SUBJECT: ISSUANCE OF AMENDMENT FOR CALVERT CLIFFS NUCLEAR POWER PLANT,
UNIT NO. 1 (TAC NO. M87690)

AMENDMENT NO. 185 TO FACILITY OPERATING LICENSE NO. DPR-53-CALVERT CLIFFS
UNIT 1

Amendment No. 185
License No. DPR-53

SAFETY EVALUATION BY THE OFFICE OF NUCLEAR REACTOR REGULATION
RELATED TO AMENDMENT NO. 185 TO FACILITY OPERATING LICENSE NO. DPR-53
BALTIMORE GAS AND ELECTRIC COMPANY
CALVERT CLIFFS NUCLEAR POWER PLANT, UNIT NO. 1
DOCKET NO. 50-317

FIGURE 3.4.9-1

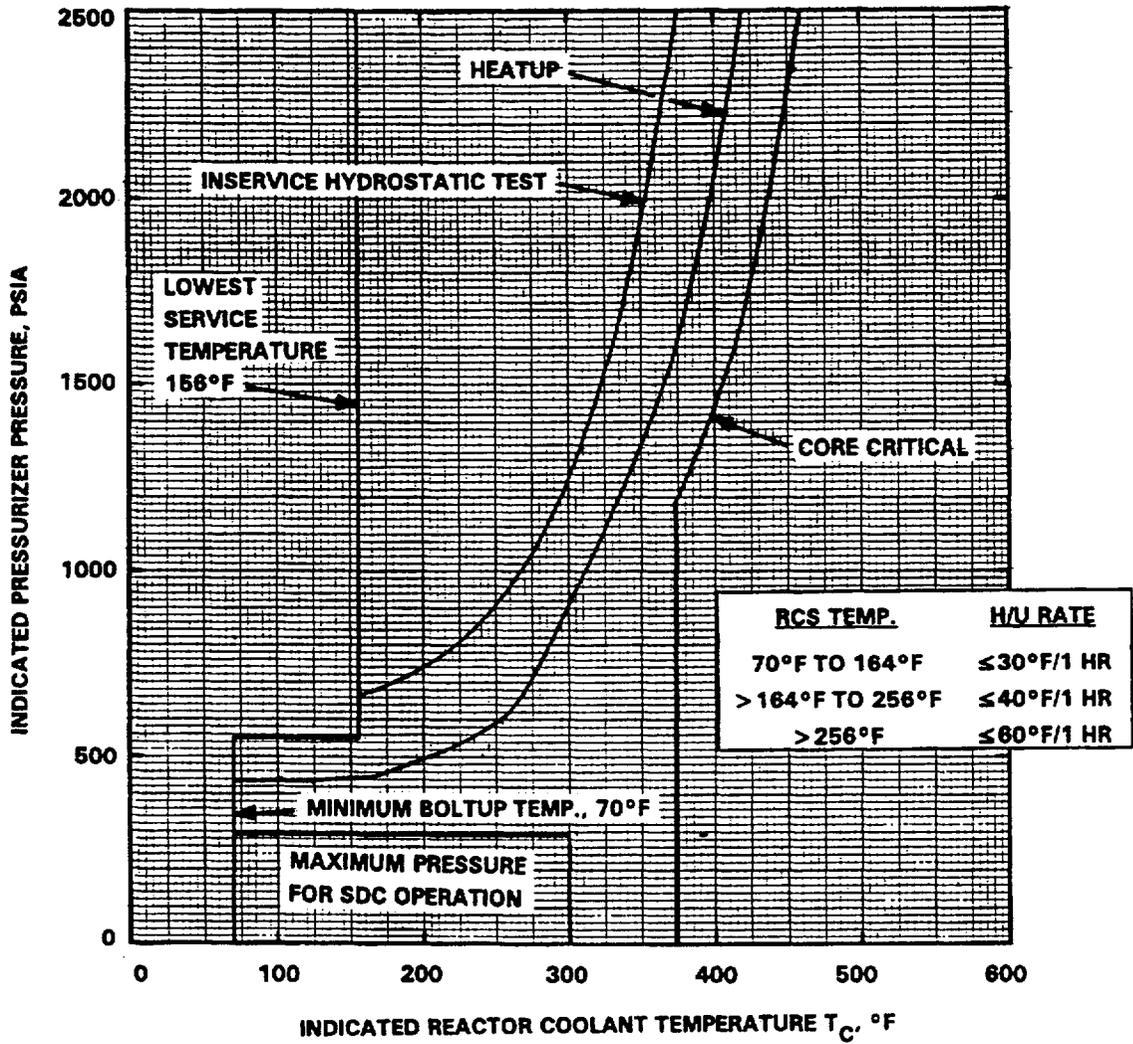
3.4.9.1 The Reactor Coolant System (except the pressurizer) temperature and pressure shall be limited in accordance with the limit lines shown on Figures 3.4.9-1 and 3.4.9-2 during heatup, cooldown, criticality, and inservice leak and hydrostatic testing with:

<u>Maximum Allowable Heatup Rate</u>	<u>RCS Temperature</u>
30°F in any one hour period	70°F to 164°F
40°F in any one hour period	> 164°F to 256°F
60°F in any one hour period	> 256°F

The changes involving the heatup and cooldowns curves and rates in TSs 3.4.9.1.a and 3.4.9.1.b, and the RCS P-T limits in Figures 3.4.9.1 and 3.4.9.2, provide the necessary protection for the Appendix G P-T limits as previously discussed in this evaluation and are, therefore, acceptable.

FIGURE 3.4.9-2

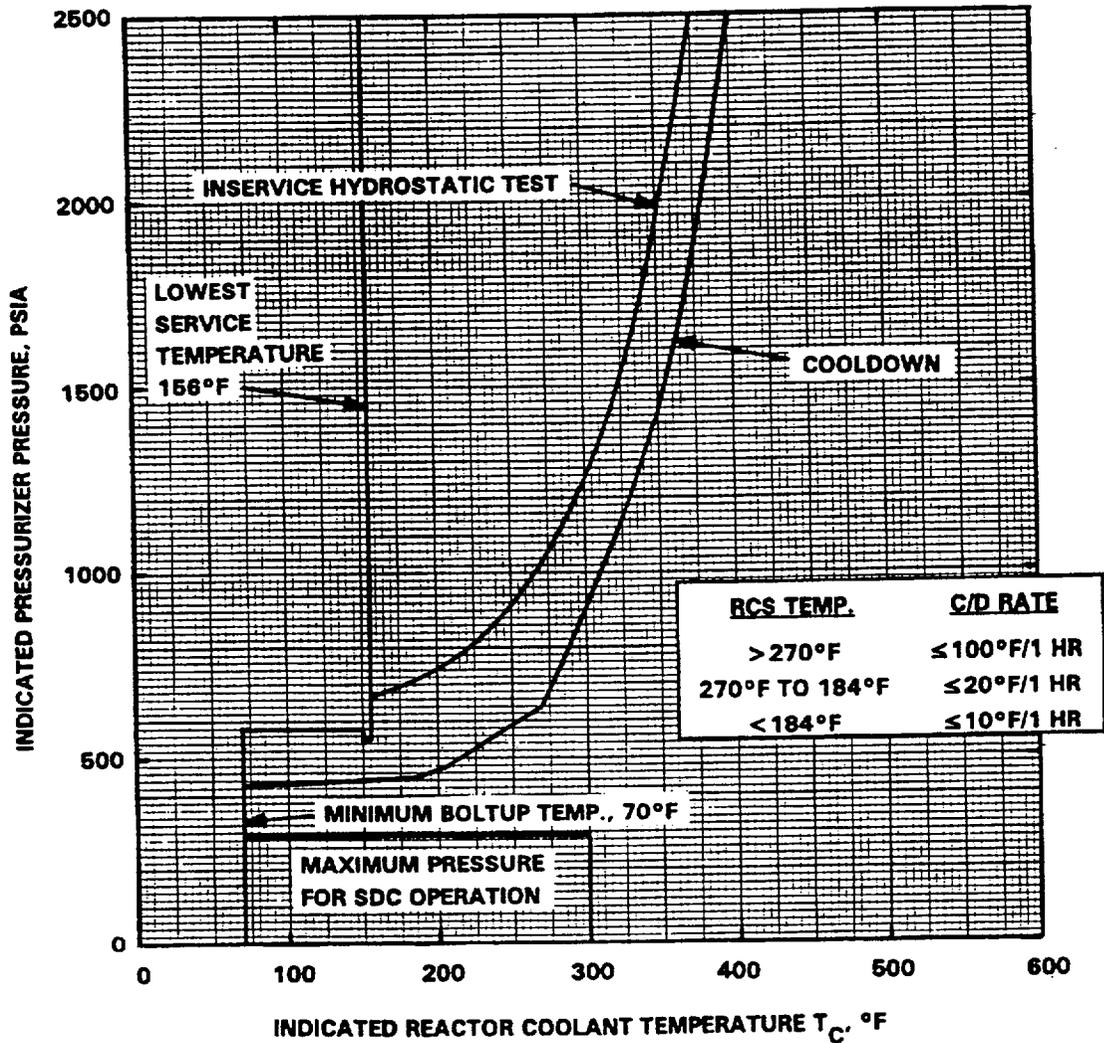
<u>Maximum Allowable Cooldown Rate</u>	<u>RCS Temperature</u>
100°F in any one hour period	> 270°F
20°F in any one hour period	270°F to 184°F
10°F in any one hour period	< 184°F

FIGURE 3.4.9-3

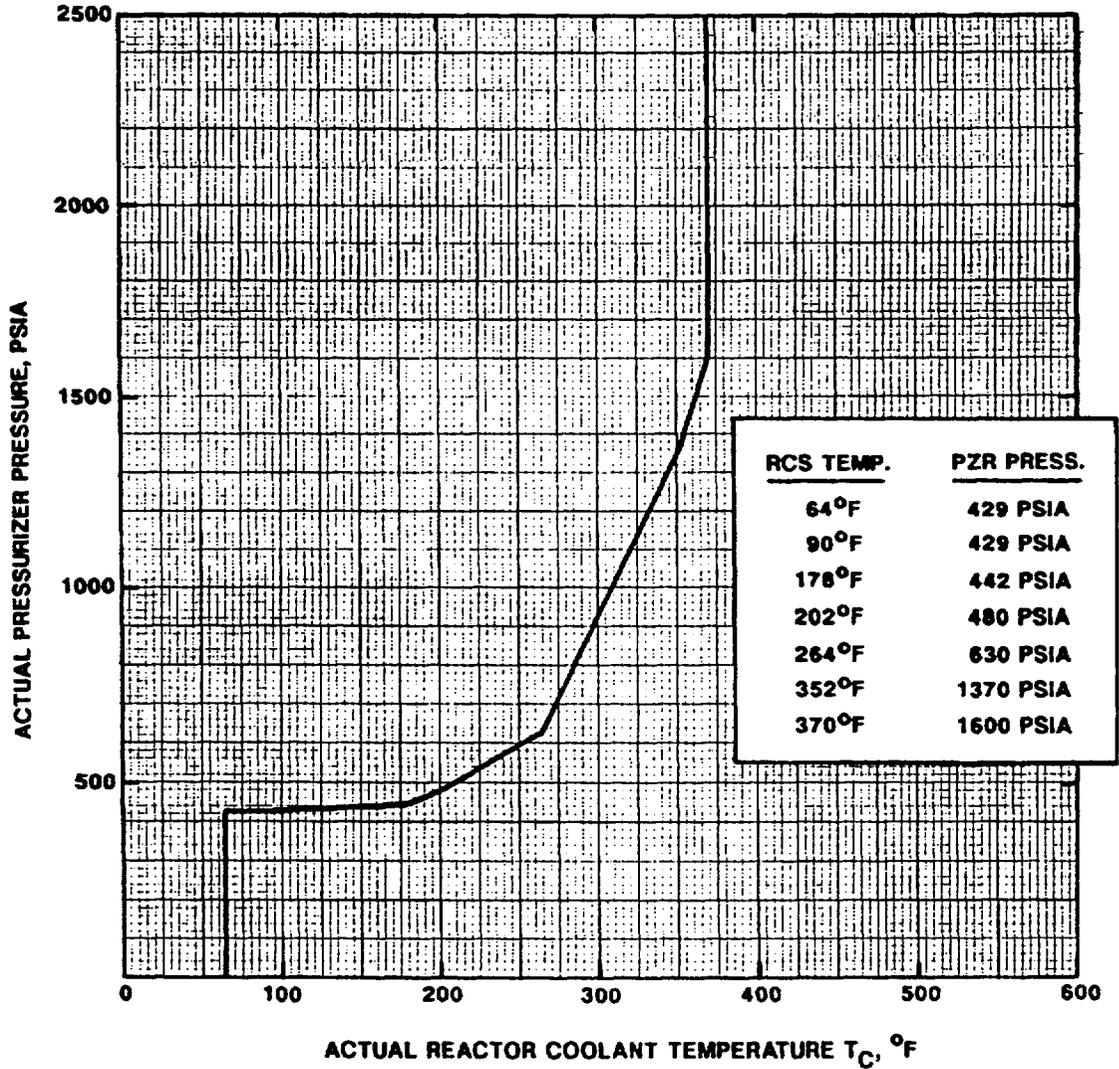
1. Two power-operated relief valves (PORVs) with a trip setpoint below the curve in Figure 3.4.9-3*, or
 2. A single PORV with a trip setpoint below the curve in Figure 3.4.9-3* and a Reactor Coolant System vent of ≥ 1.3 square inches, or

* When on shutdown cooling, the PORV trip setpoint shall be ≤ 429 psia. |

Additional TS changes are proposed to account for the revised heatup and cooldown rates and support a VLTOP system. Specifically, TSs 3.4.9.3.a.1 and 3.4.9.3.a.2 change the pressure limit and the footnote to Figure 3.4.9-3*, TSs 3.1.2.1, and 3.1.2.3. Table 3.3-3, TSs 3.4.1.2, 3.4.1.3, 3.4.9.3, 4.5.2, 3.5.3, Bases 3/4.4.1, Bases 3/4.4.9 and Bases 3/4.5.2 change the minimum Enable temperature from 355 °F to 365 °F. TS 3.5.3 and Table 3.3-3 change the higher Enable temperature when the high-pressure safety injection (HPSI) pumps are placed under manual control on cooldown (and return to automatic on heatup) from 355 °F - 375 °F to 365 °F - 385 °F, TS 3.4.9.3 Bases 3/4.4.9 and Bases 3/4.5.2 change the maximum allowable HPSI pump flow from 200 gpm to 210 gpm. Bases 3/4.4.1 coolant loop and coolant circulation, Bases 3/4.4.9 P-T limits and Bases 3/4.5.2 emergency core cooling system subsystems were changed to be consistent with the above.
